Comments on #SDP-26-0004 - Planning & Zoning: Site Development Plan

Application Number: #SDP-26-0004
Application Type: Site Development Plan
Date: July 29, 2026
Address: 705 S MAIN ST, ROLESVILLE, NC 27571
Parcel: 1758574058

SITE DEVELOPMENT PLAN - SDP 26-__

REQUIRED VEGETATION PLAN
WALLBROOK SHOPPES (LOT 5C)

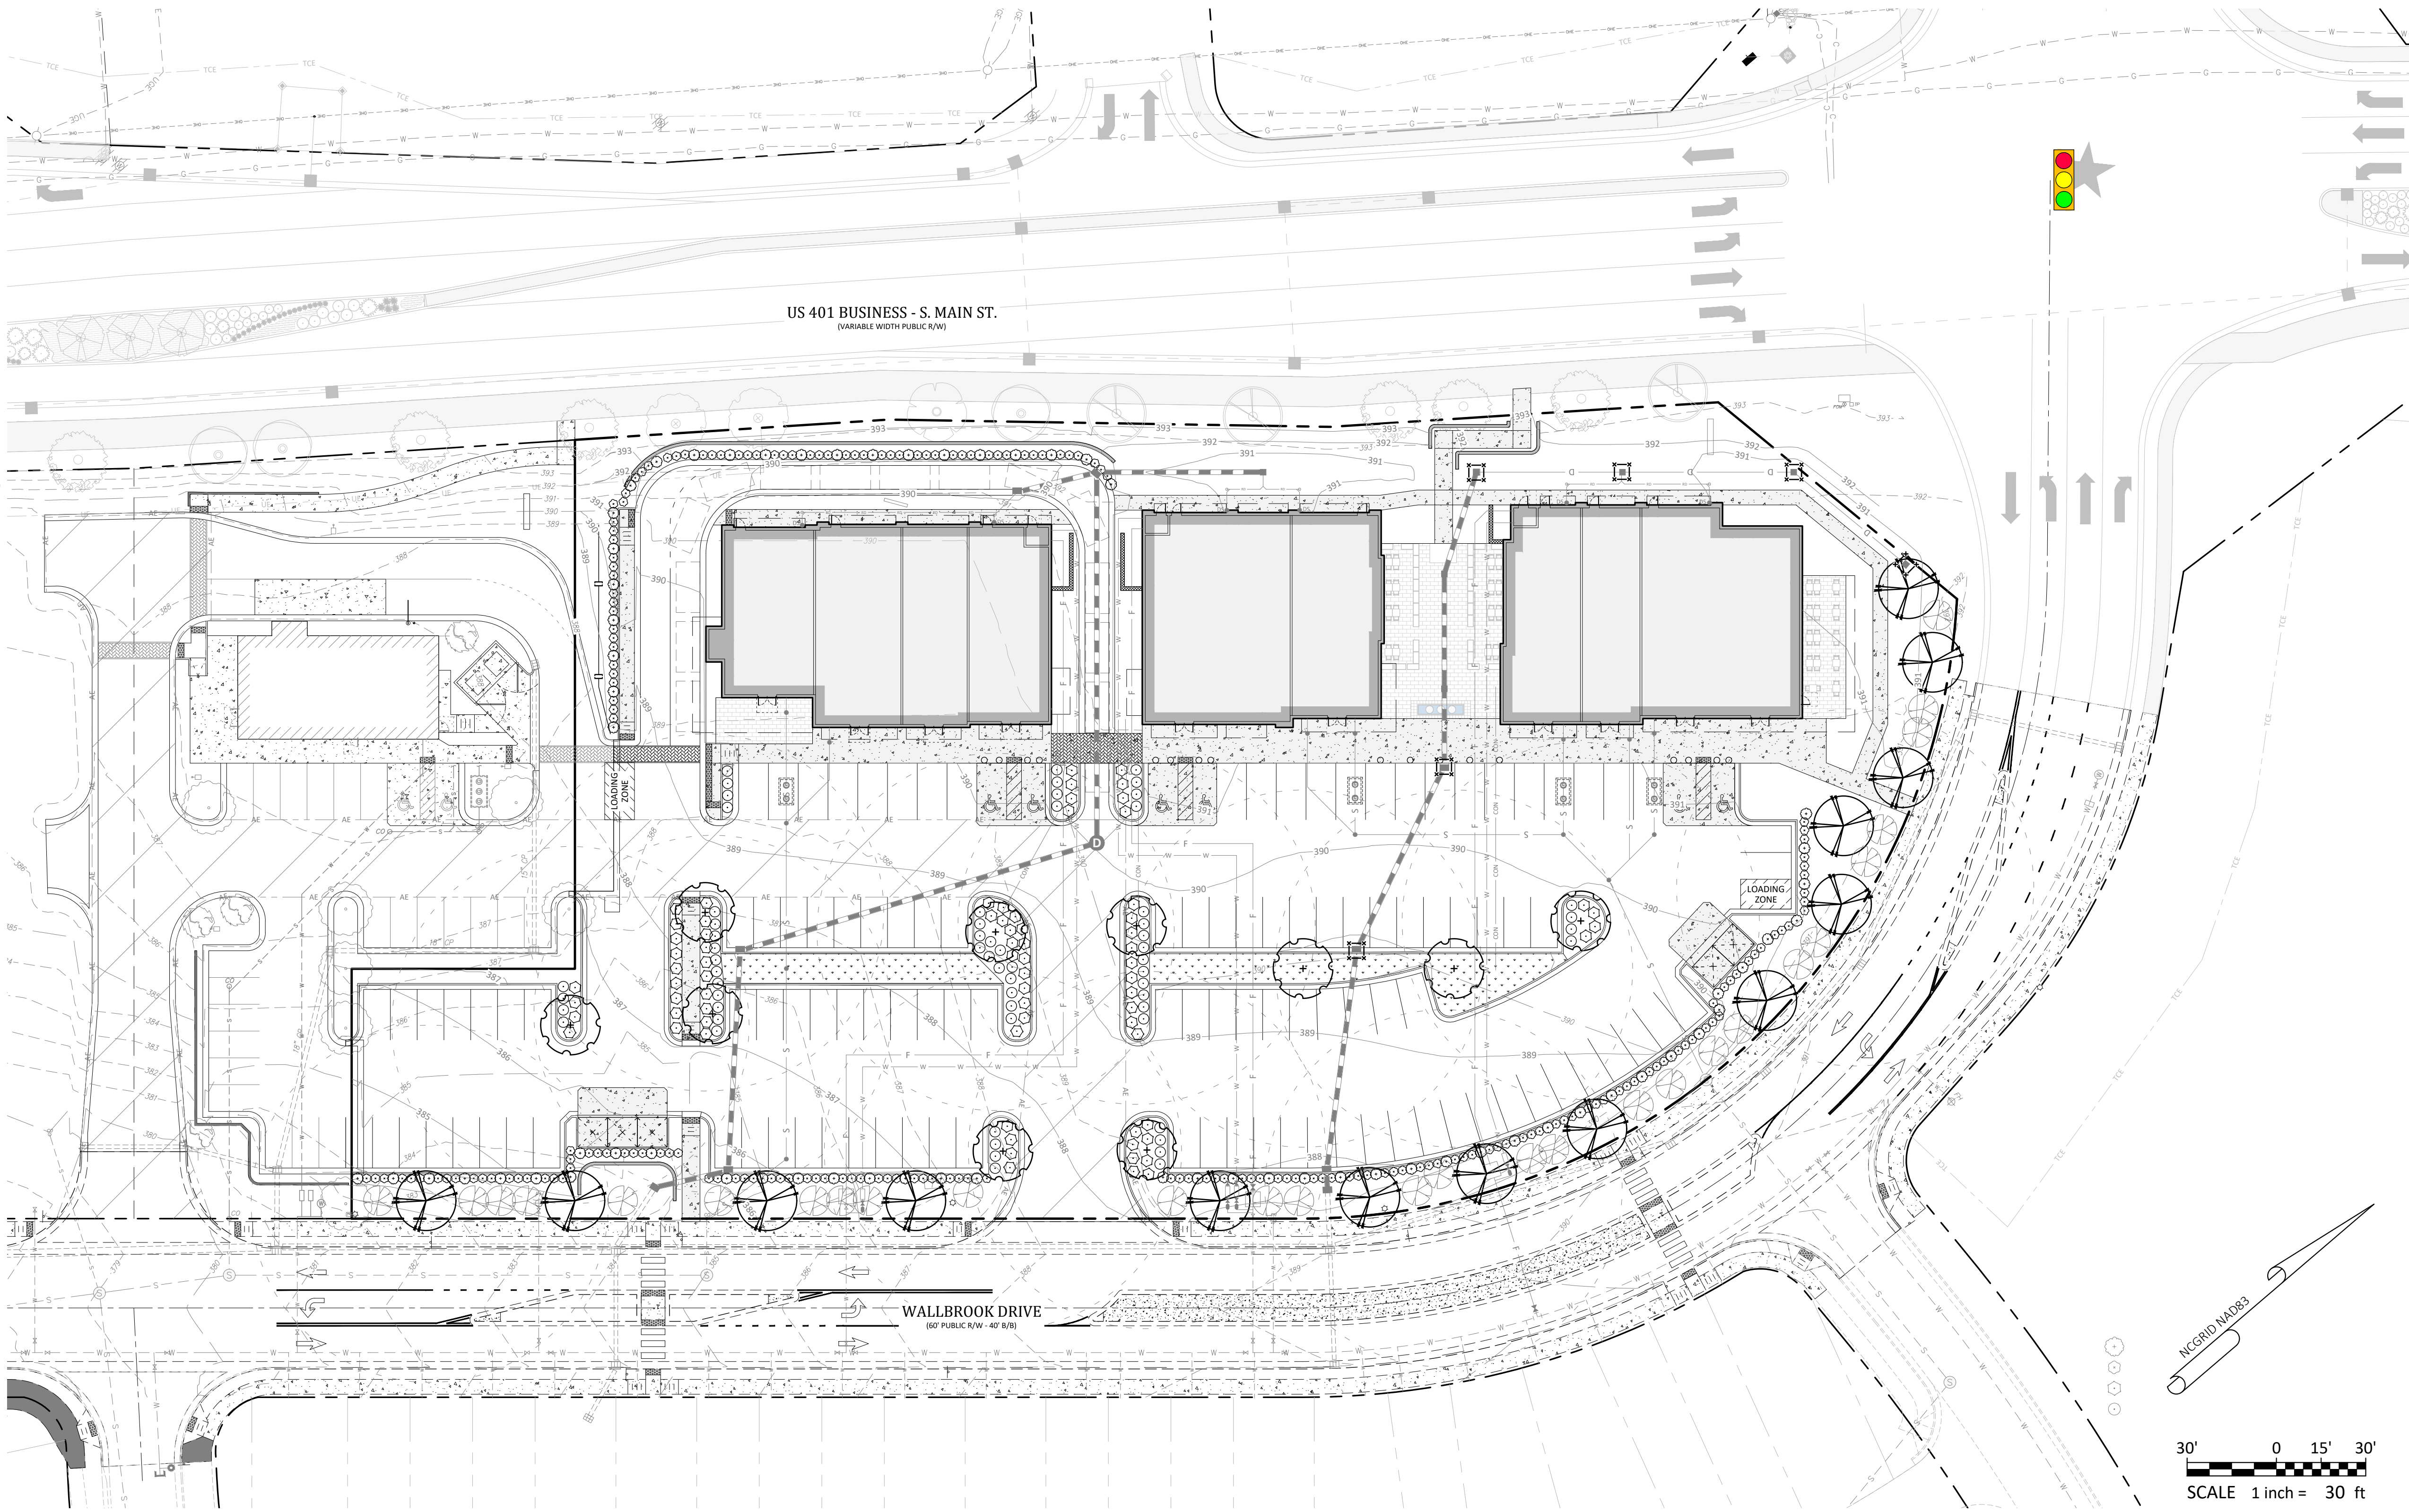
Add Interior island tree is required per Section 6.2.4.4.F.

Add Interior island tree is required per Section 6.2.4.4.F.

required planting to terminal island per Section 6.2.4.4.D.4

Add tree per Section 6.2.4.4.D.3

Add tree per Section 6.2.4.4.D.3

Add Interior island tree is required per Section 6.2.4.4.F.

Add Interior island tree is required per Section 6.2.4.4.F.

required planting to terminal island per Section 6.2.4.4.D.4

Add tree per Section 6.2.4.4.D.3

Add tree per Section 6.2.4.4.D.3
